STATE OF MAINE
DEPARTMENT OF HUMAN SERVICES
AUGUSTA, MAINE 04333

Subject: Waiver to the Maine Plumbing Code, Part II,
Corkum property, Bolton Hill Road, Augusta

Re: Replacement Sewage Disposal
System for the Lawrence Corkum
Property, Bolton Hill Road,
Augusta, Maine.

• SEWAGE DISPOSAL BED DETAILS •

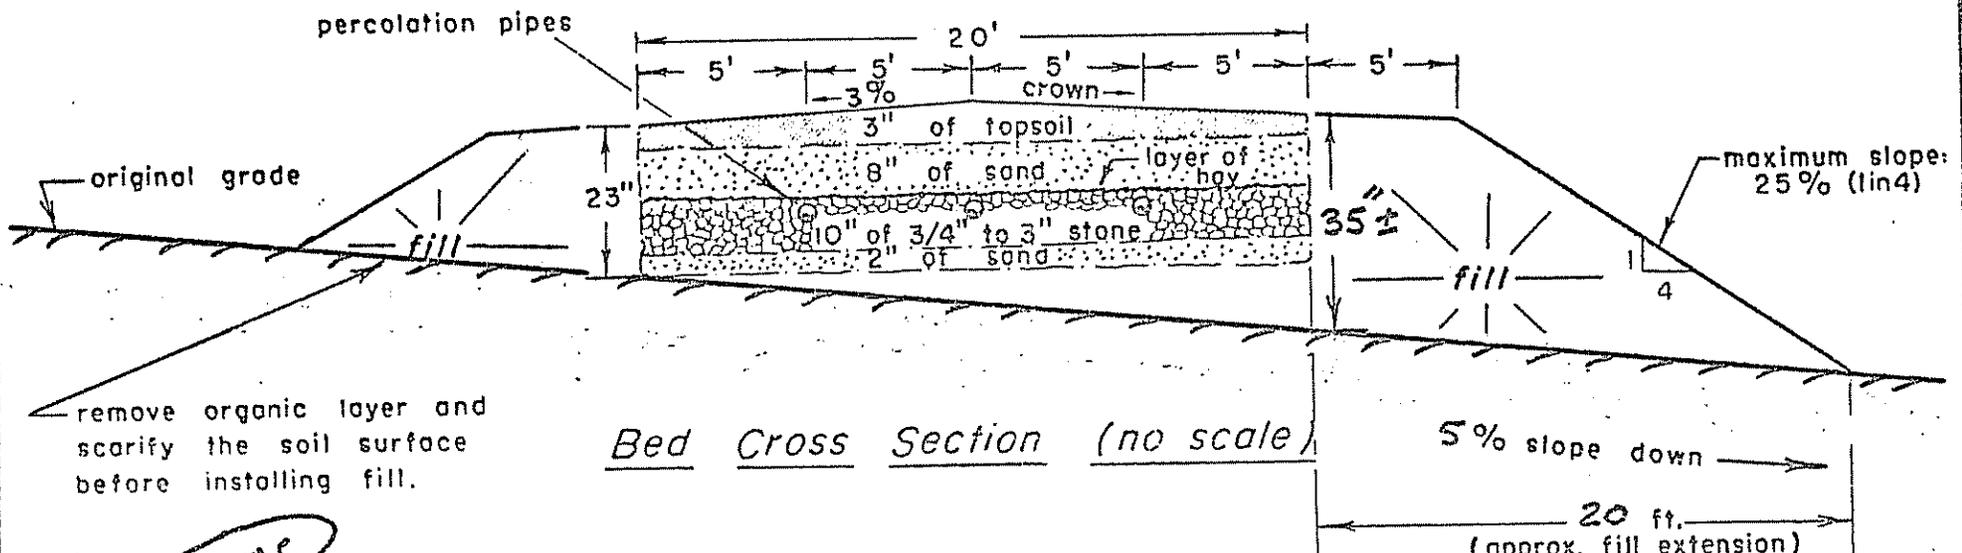
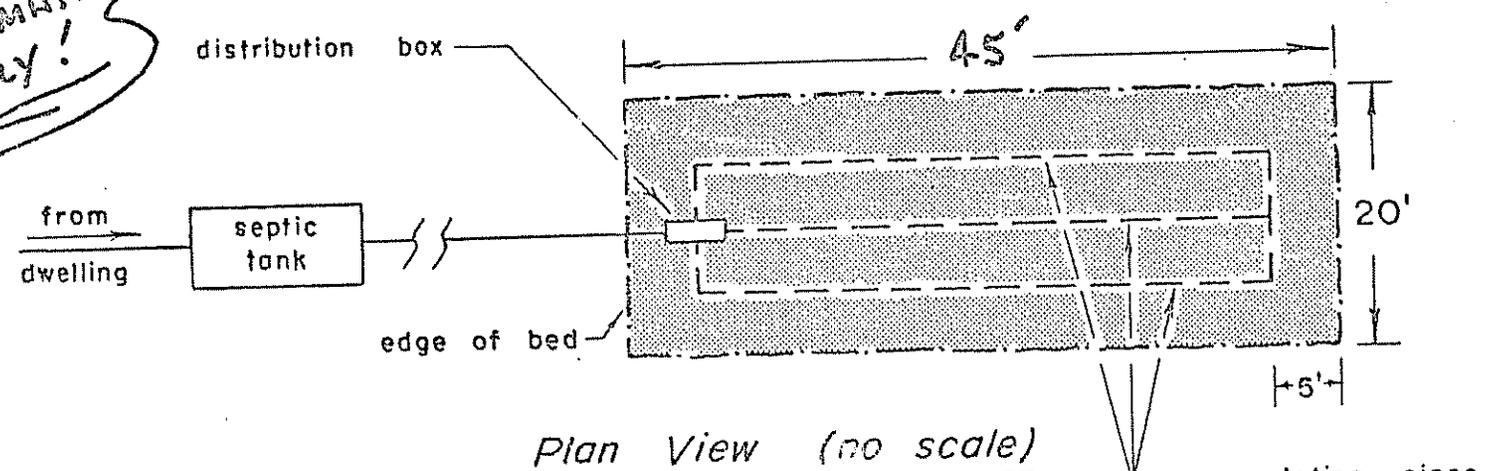
The use of the existing 750 gallon septic tank to be followed by a 45'x20' disposal bed. The bottom of the bed is to be at least 18 inches above mottling. The fact that this system is smaller than required by plumbing code shall be duly recorded with the deed at the appropriate registry of deeds.

At least 23 inches and 35 inches of fill shall be applied on the uphill and downhill sides of the bed, respectively. This fill shall be of a texture similar to the original soil and will provide an 18 inch separation between the bottom of the disposal bed and the seasonal high water table and impervious layer. The fill must be extended in all directions as required by Section 8.7 of the Maine Plumbing Code, Part II.
